# SETTLERS RANCH

## Filing No. 2C

# Construction Drawings

## El Paso County, Colorado

SHEET **G1C**  
JPS PN# 030501

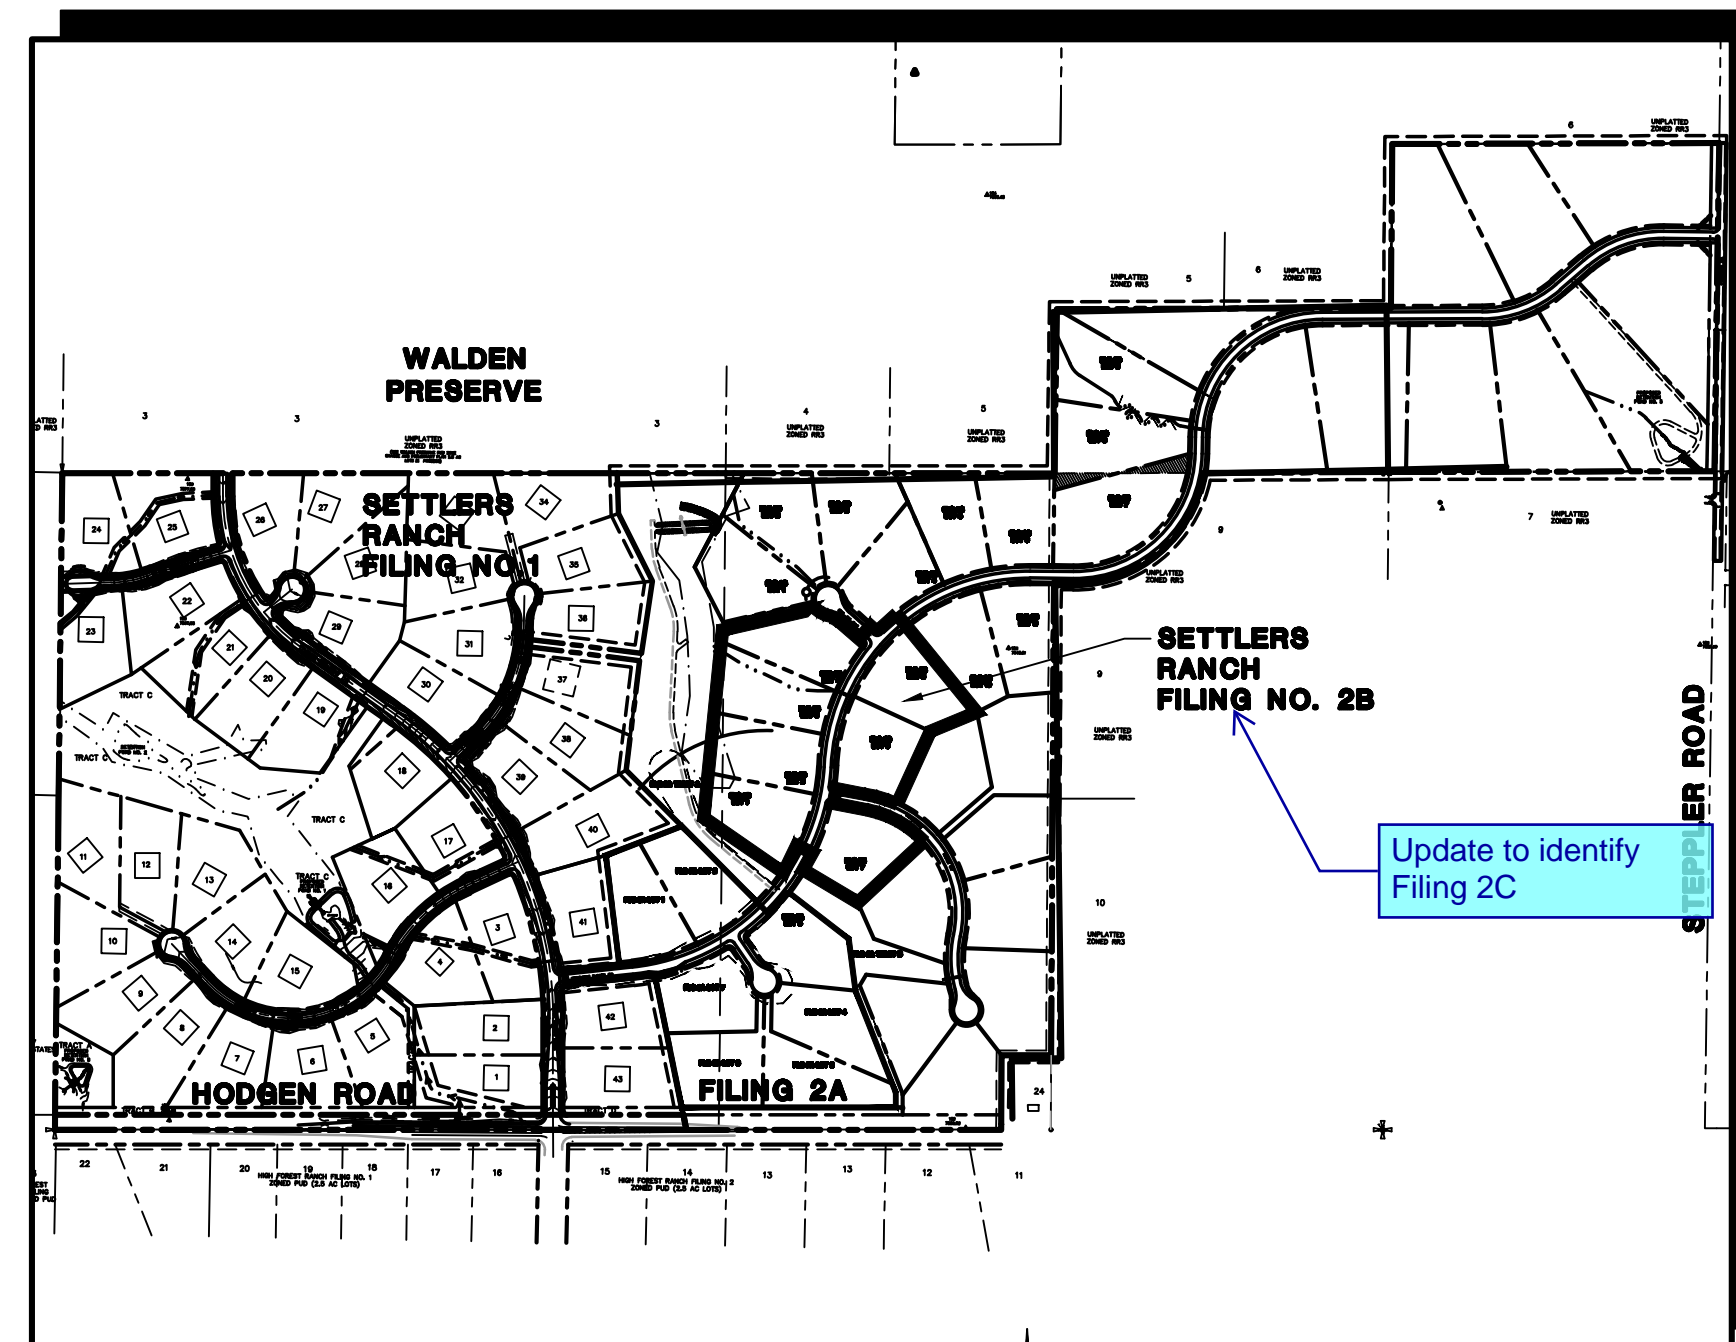
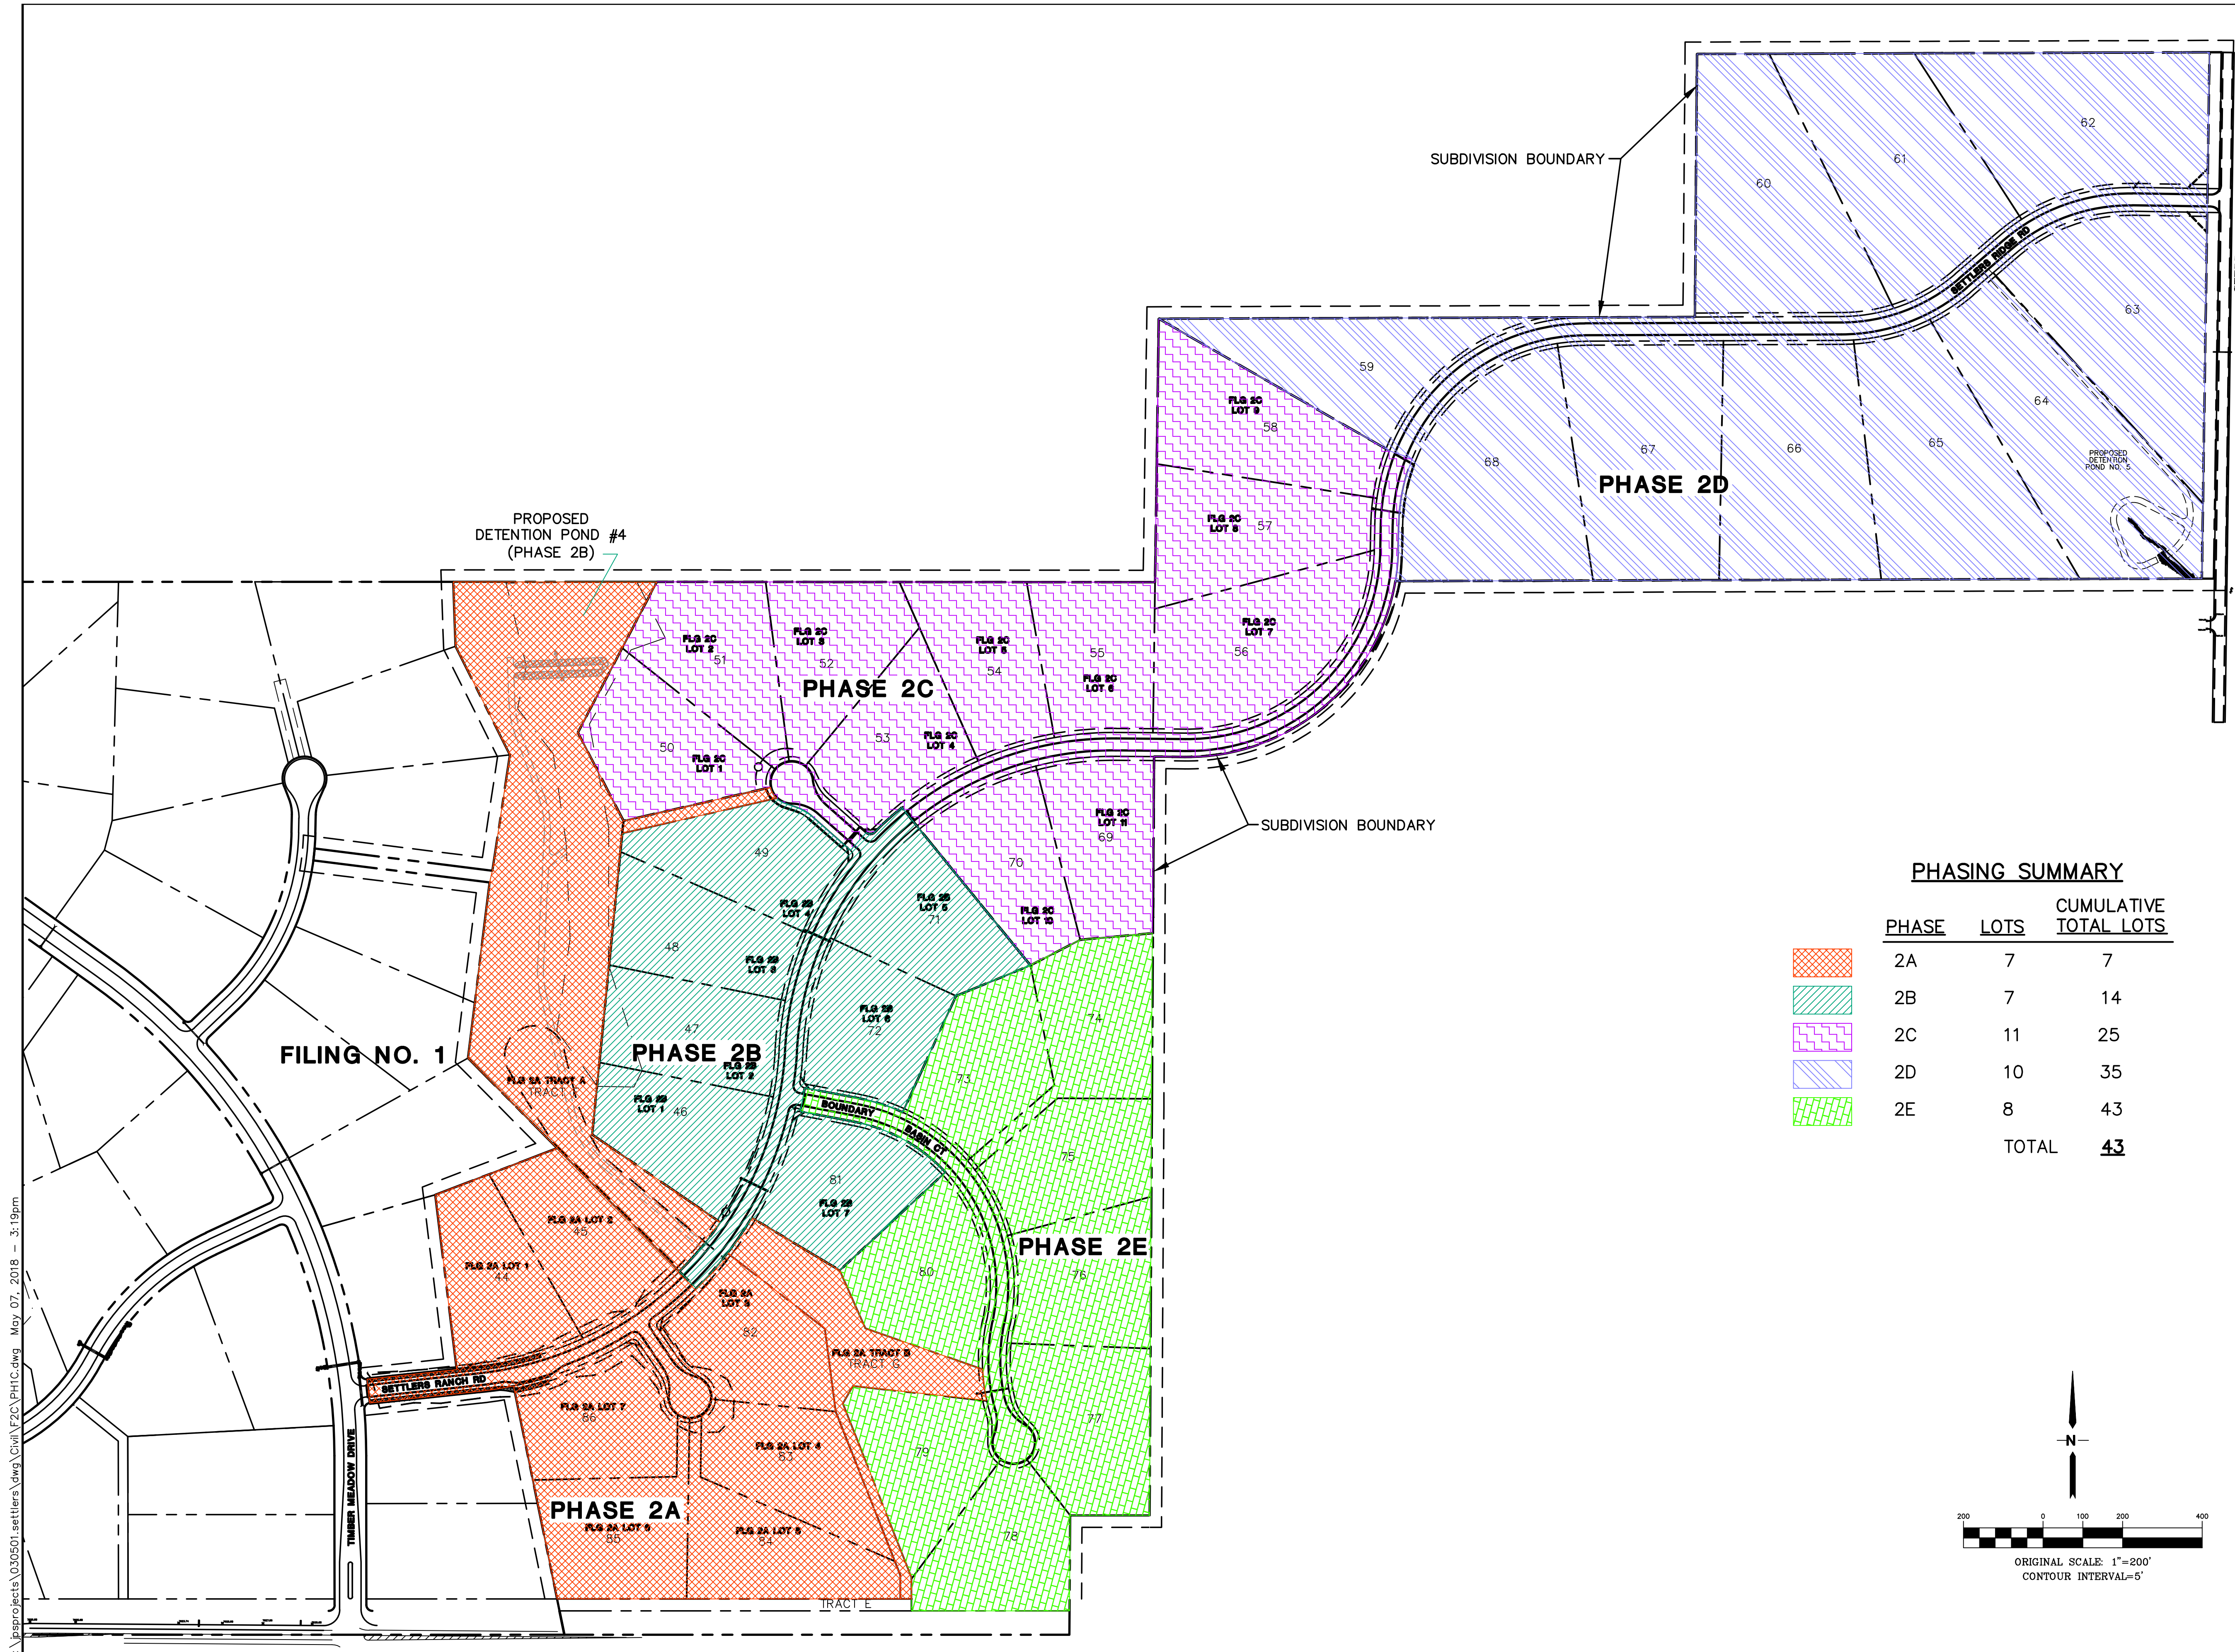
Update to include the following as a 3rd paragraph:  
In accordance with ECM Section 1.12, these construction documents will be valid for construction for a period of 2 years from the date signed by the El Paso County Engineer. If construction has not started within those 2 years, the plans will need to be resubmitted for approval, including payment of review fees at the Planning and Community Development Directors discretion.

Add "PCD File No. SF-18-018"

**OVERALL SITE PLAN & GENERAL NOTES**

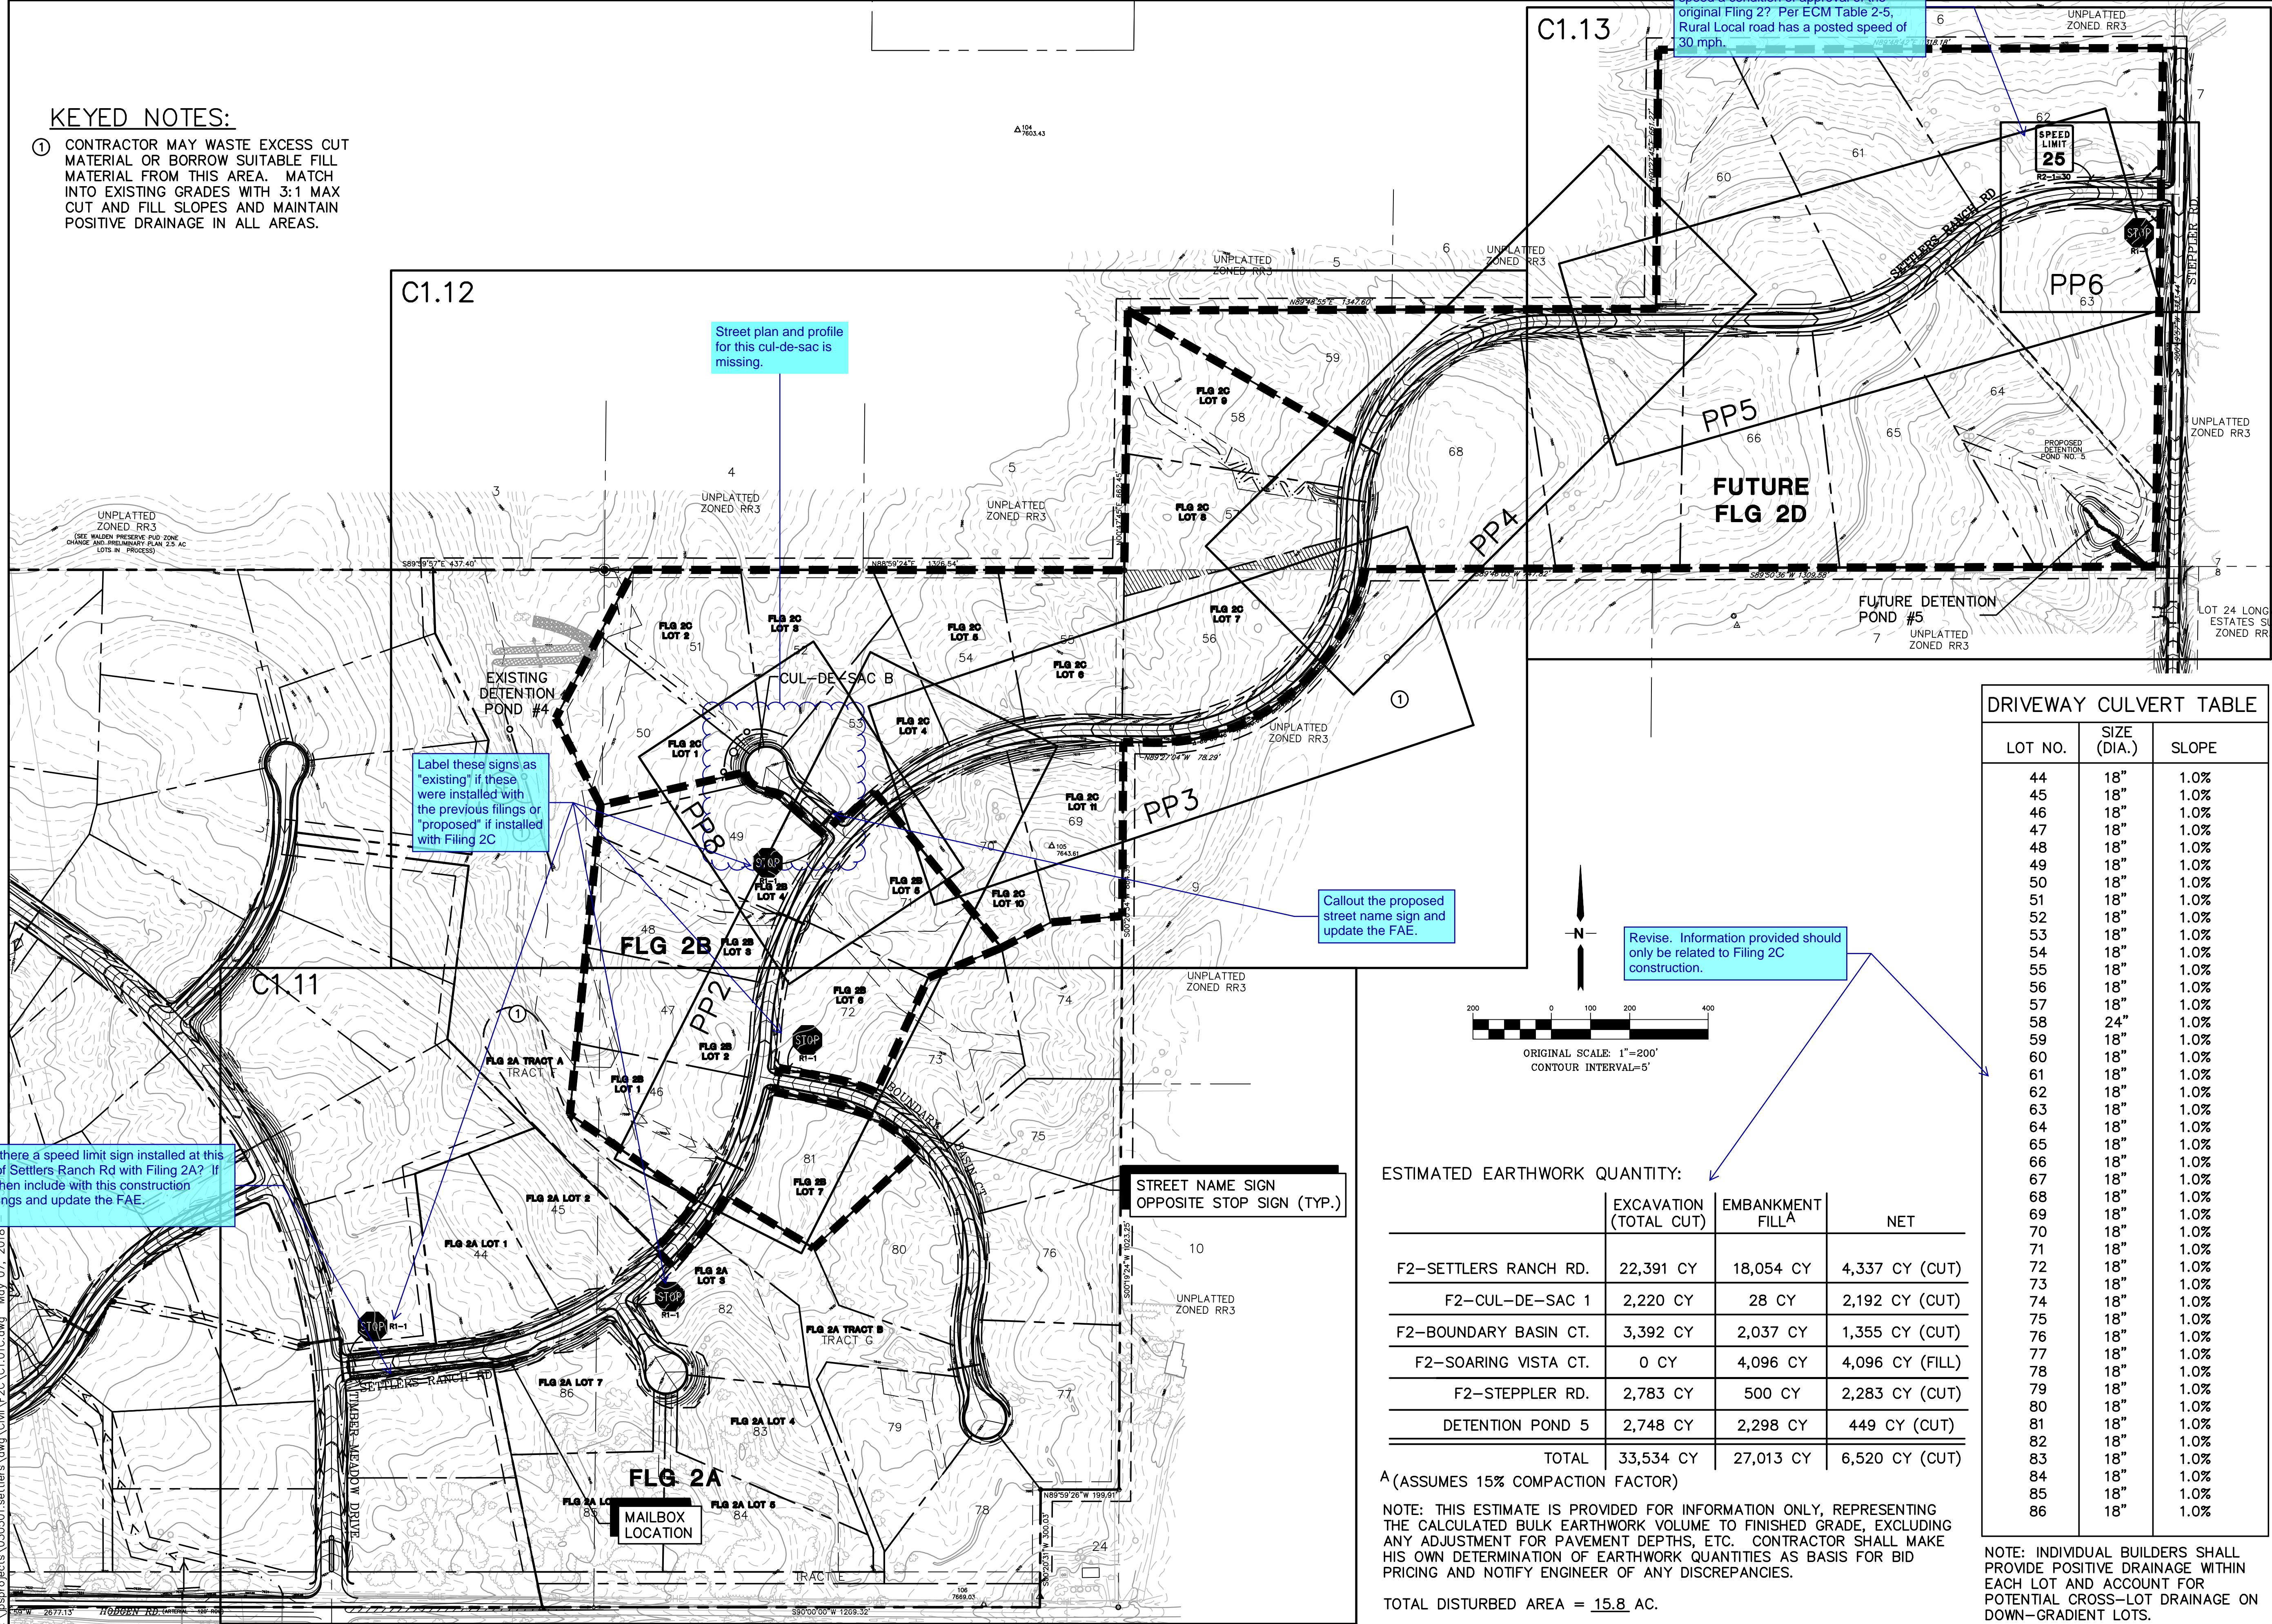
Update any reference from Development Services Department (DSD) to Planning and Community Development (PCD)

EROSION CONTROL NOTES & DETAILS

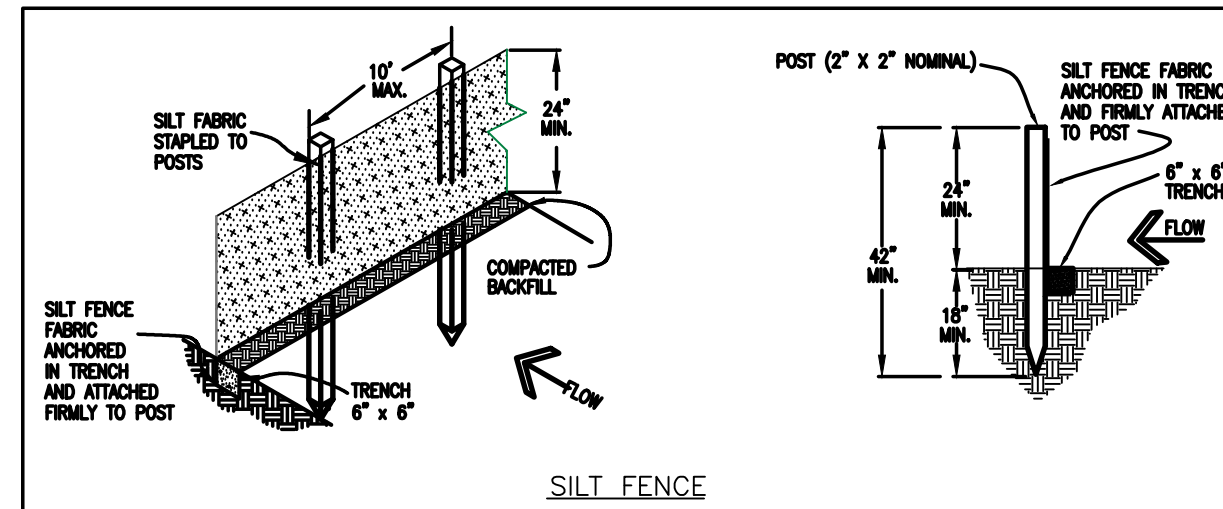
remove the word 'preliminary'
